PREDETERMINATION SETTLEMENT AGREEMENT

CP# 08-14-66216
HUD# 07-14-0636-8

1688 RADFORD ROAD RESIDENTIAL COOPERATIVE, INC.

Complainant's Allegations:

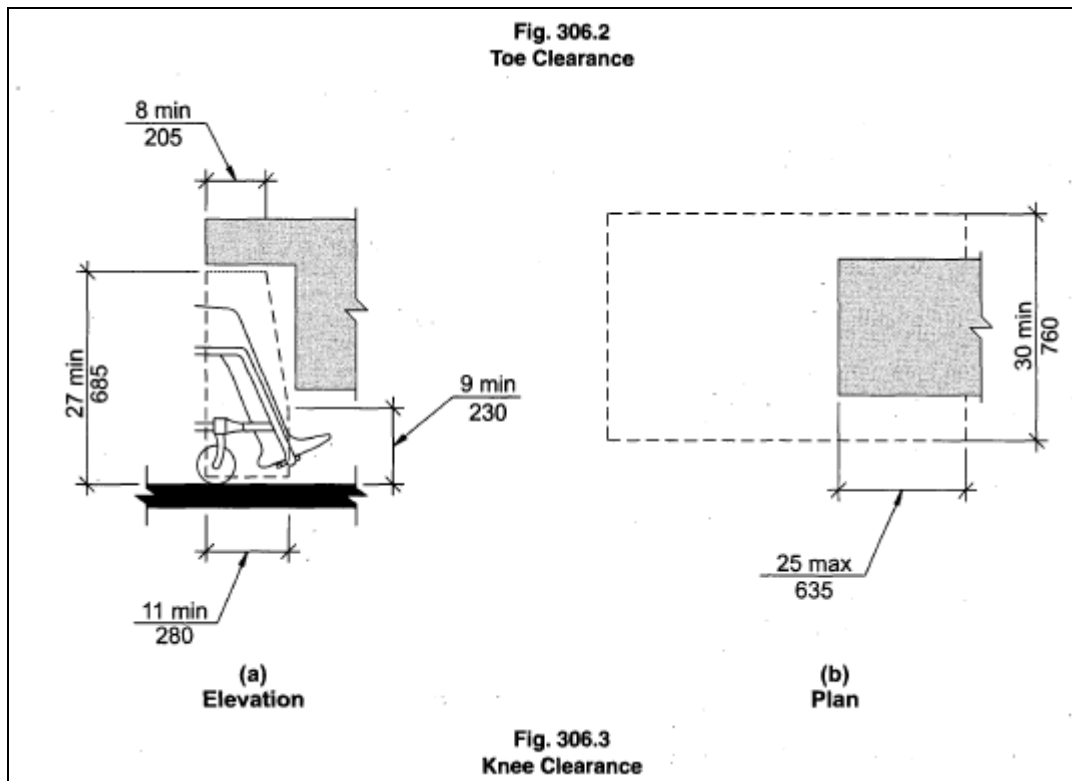
- (a) The parties agree the distance from the midline of the sink to the adjacent wall in the master bathroom for Unit 7 was measured at under the 24-inch minimum for bathroom sinks without removable cabinets, as required by the Guidelines. Respondents maintain the vanity cabinet underneath these sinks is removable.
- (a) Respondents agree to complete the following steps in order to confirm the vanity cabinets in the master bathroom are removable:
 - 1) Illustrate how the bathroom cabinet would be removed by submitting a step-by-step, detailed description of the entire process, documenting the amount of time required to complete each step.
 - 2) Submit a video file showing how the cabinet is removed. If a video is not possible, provide photographs of each step in the removal process.

- 3) Once the cabinet is removed, take and provide photographs of each measurement to assess compliance with the “knee clearance” requirements from ANSI 2003, as indicated in the figure at the top of the next page. The measurements needed include:
 - a. Height from floor to bottom edge, or the underneath horizontal surface, of the vanity counter.
 - b. Height from floor to the fixture (water pipes, etc.) above where the toes for someone in a wheelchair would normally be when making the forward approach.
 - c. Depth of knee space from front edge of counter to fixture underneath counter.
 - d. Width of the knee space below the vanity counter.
- 4) Also, provide a description, as well as supporting video or photographs to indicate whether the wall behind the removed cabinet, and the surrounding cabinetry, which would otherwise be hidden from view by the removed cabinet, are finished.
